**Minutes of the Town of Perinton
Planning Board Meeting of May 21, 2014**

Basin View Subdivision. T.Y. Lin International, as agent for Longwell Builders, LLC, owner of property located on the south side of East Jefferson Road (NYS Route 96) (tax account #179.09-2-24.1) west of Thornell Road, requesting final subdivision approval for a 12 lot single family subdivision.

RE: Final Subdivision Review
Basin View Subdivision
East Jefferson Road
NYS Route 96
Town of Perinton

EXHIBIT "B"
ROOF TOP PLAN

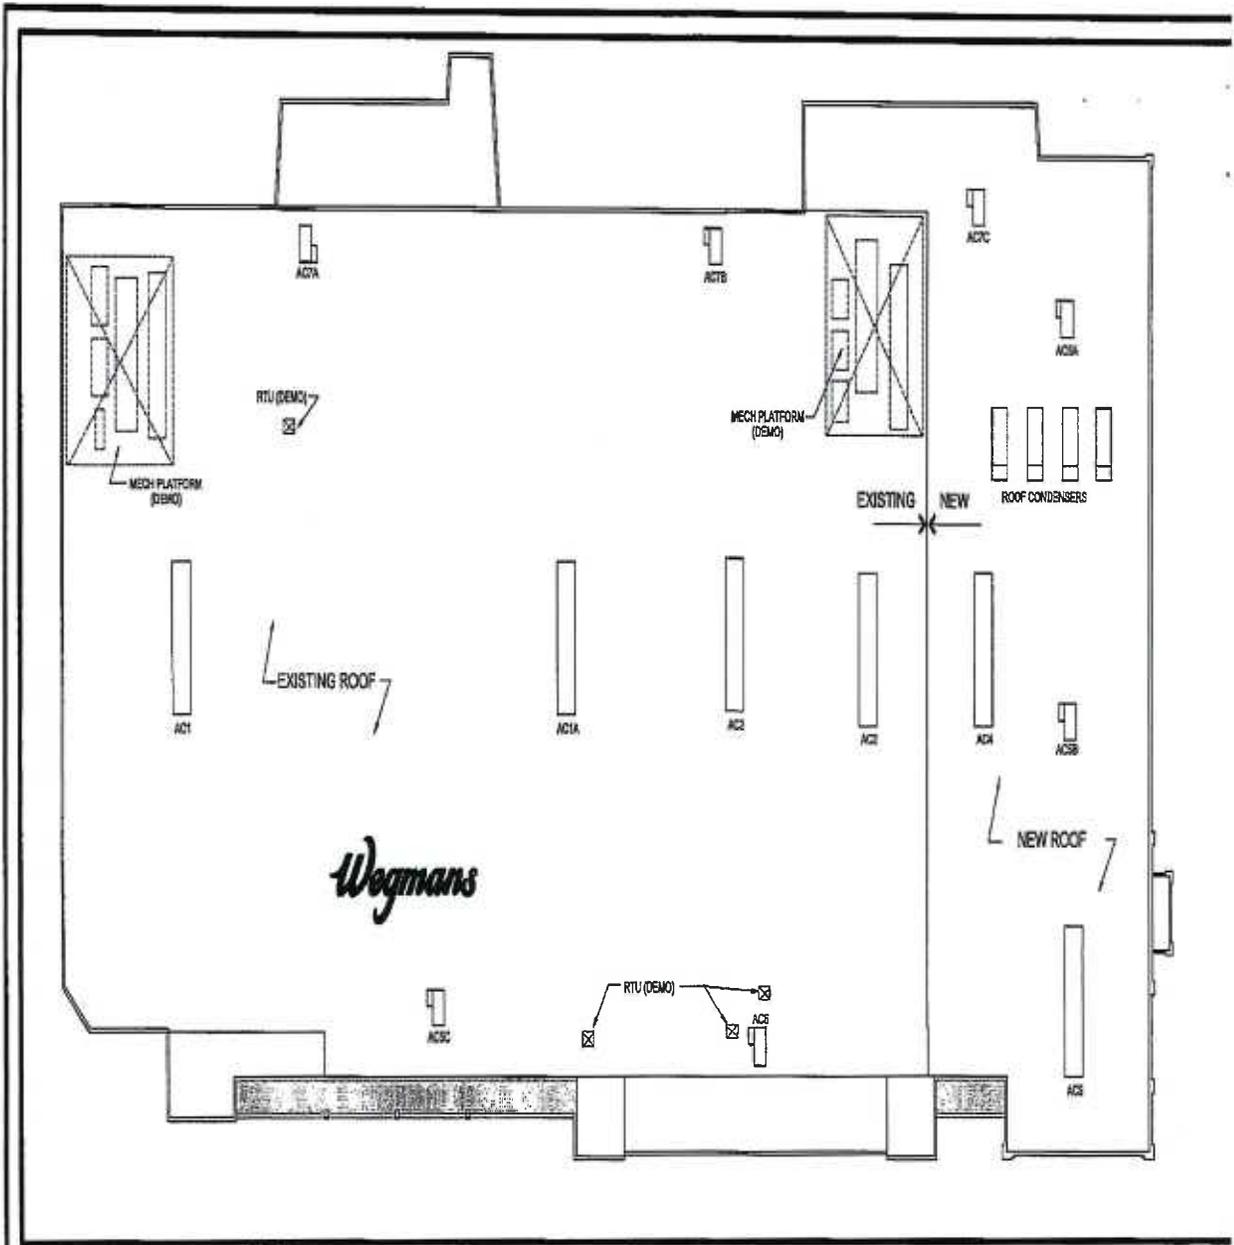
As illustrated in **Exhibit B**, the two existing large mechanical penthouse platforms containing condensers, compressors, refrigeration, and air conditioning units that are now located on the northwest and northeast corners of the market, will be removed. The large and louder refrigeration and compressor units are planned to be replaced, with the new more efficient units being installed within the building, below the building roof, eliminating that significant noise source.

**Attachment A
Figure 1
Receptor Location**

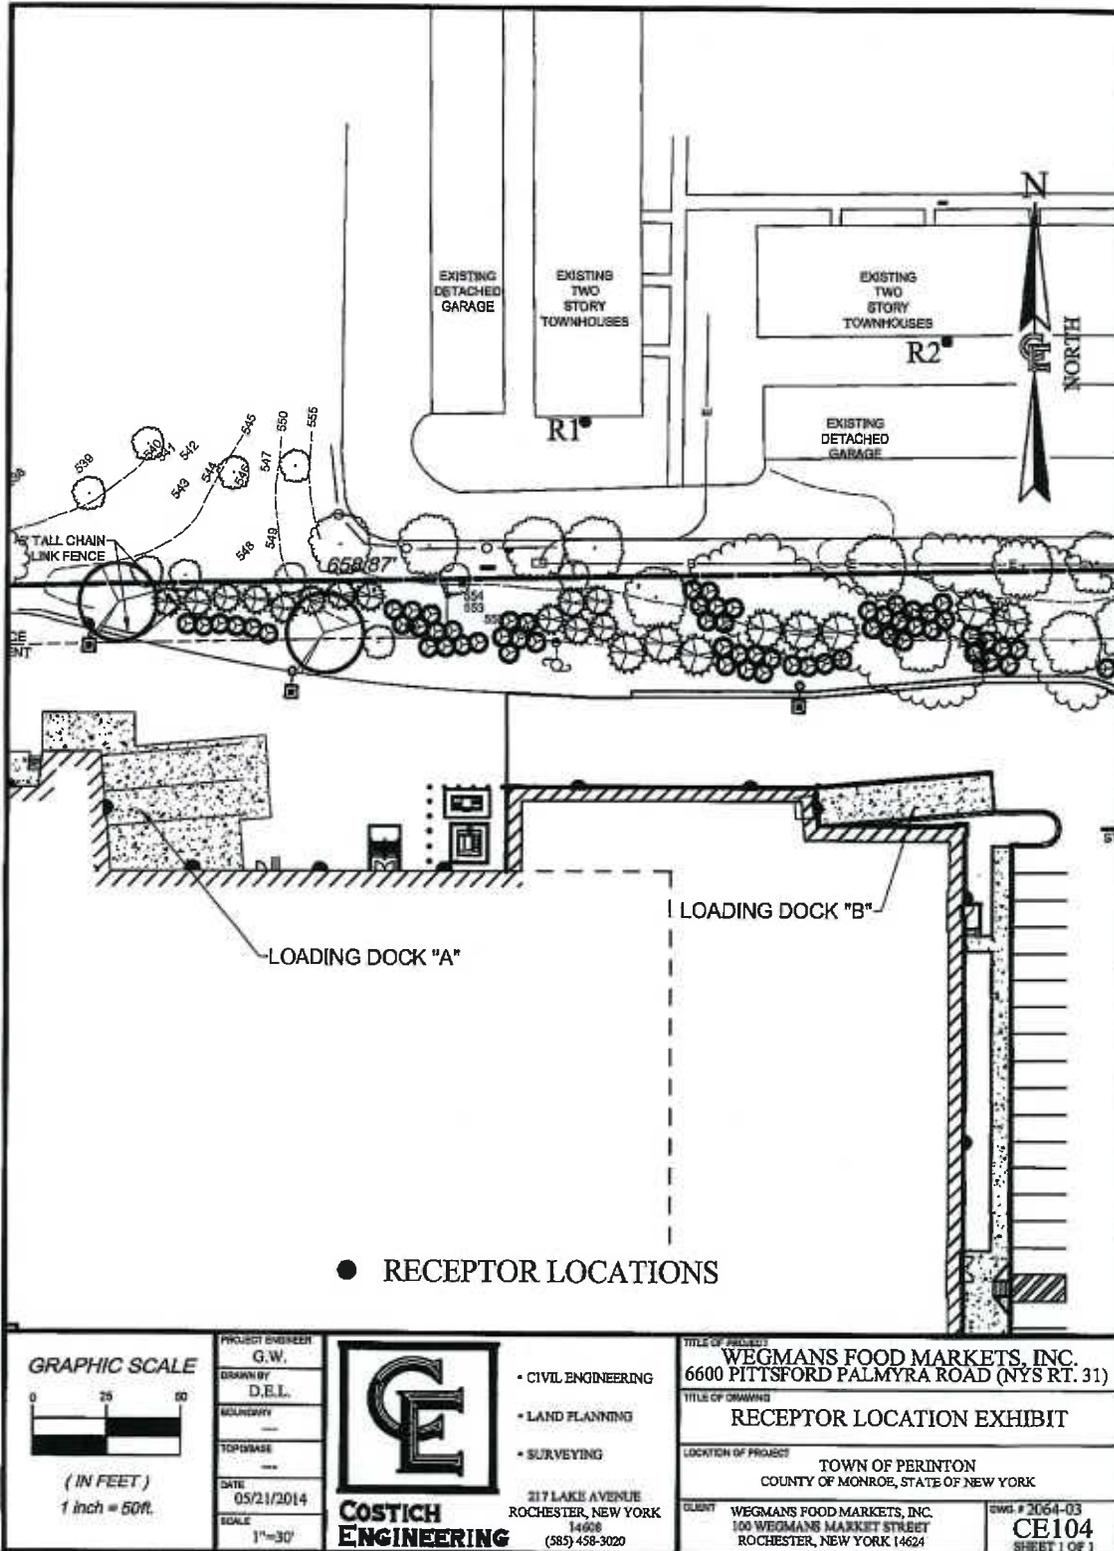
Following the NYS DEC guidance, the analysis focuses on the worst case scenario consisting of the maximum noise generated and its effect on the closest points on the residential buildings. To this end, two receptor locations were chosen, designated receptor R1 and receptor R2 as shown in Figure 1 contained in Attachment A to this letter. Receptor R1 is located at the closest point to the Wegmans' northern property line of the existing, western residential building in Georgetown Commons. This is also the closest point to the existing eastern delivery bays now used for daytime and overnight deliveries. Receptor R2 is located at the closest point to the new delivery bays to be constructed as part of the building expansion. This residential building is oriented east-
